Project	IEEE 802.16 Broadband Wireless Access Working Group < http://ieee802.org/16 >	
Title	Handover with Relays (Section 15.6.2.5.2, Section 15.6.2.5.3)	
Date Submitted	2009-11-06	
Source(s)	Gauri Joshi, Srinadh B, Abhay Karandikar, Prateek Kapadia TICET, IIT Bombay	Voice: +91-9820347269 E-mail: karandi@ieee.org
Re:	IEEE 802.16m-09/0057: Letter Ballot Recirc #30a Target Topic: IEEE P802.16m/D2: Section 15.6.2.5	
Abstract	An ABS-anchored inter-ARS handover process is proposed	
Purpose	For discussion and adoption by TGm in the 802.16m amendment	
Notice	<i>This document does not represent the agreed views of the IEEE 802.16 Working Group or any of its subgroups. It represents only the views of the participants listed in the "Source(s)" field above. It is offered as a basis for discussion. It is not binding on the contributor(s), who reserve(s) the right to add, amend or withdraw material contained herein.</i>

Handover with Relays

Figure xxx— ARS to ARS intra-cell HO Procedure

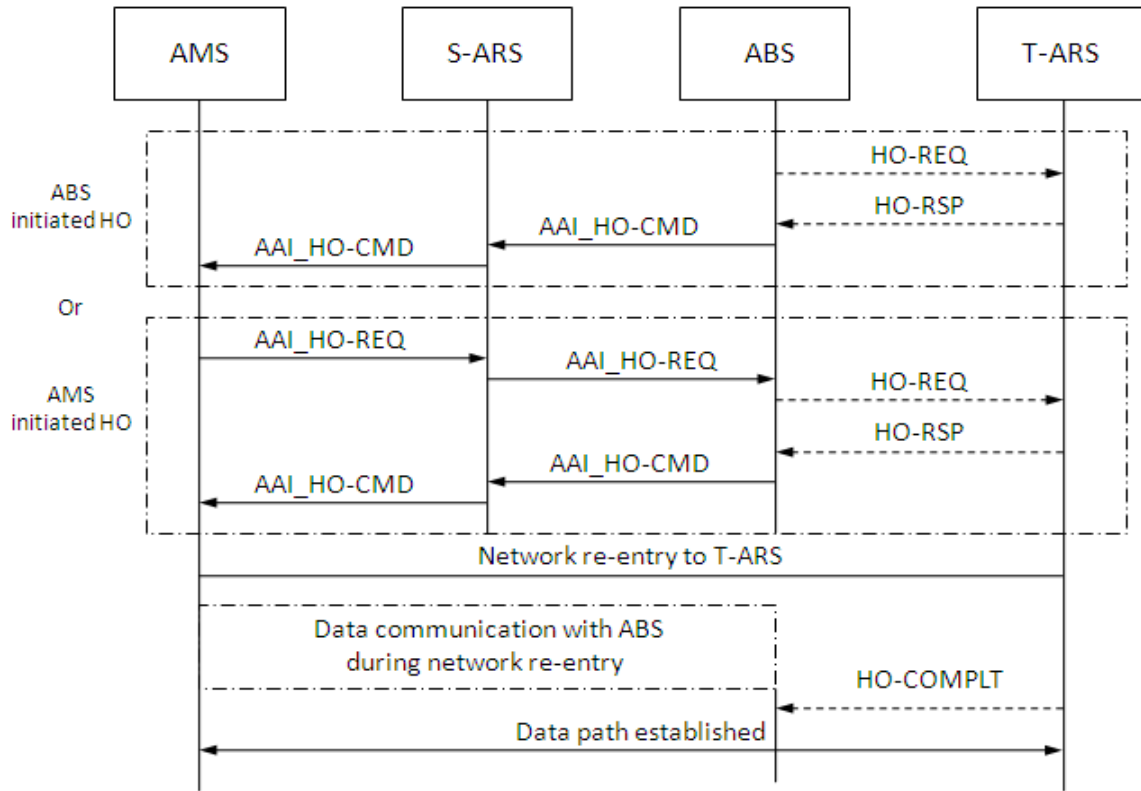
The handover process for inter-ARS, intra-cell handover is similar to the process defined in Section 15.2.6.3. The only modifications are:

1. The S-ARS relays AAI_HO-REQ and AAI_HO-CMD between AMS and ABS.
2. The HO-COMPLT, HO-REQ and HO-RSP messages are exchanged by the ABS and T-ARS.
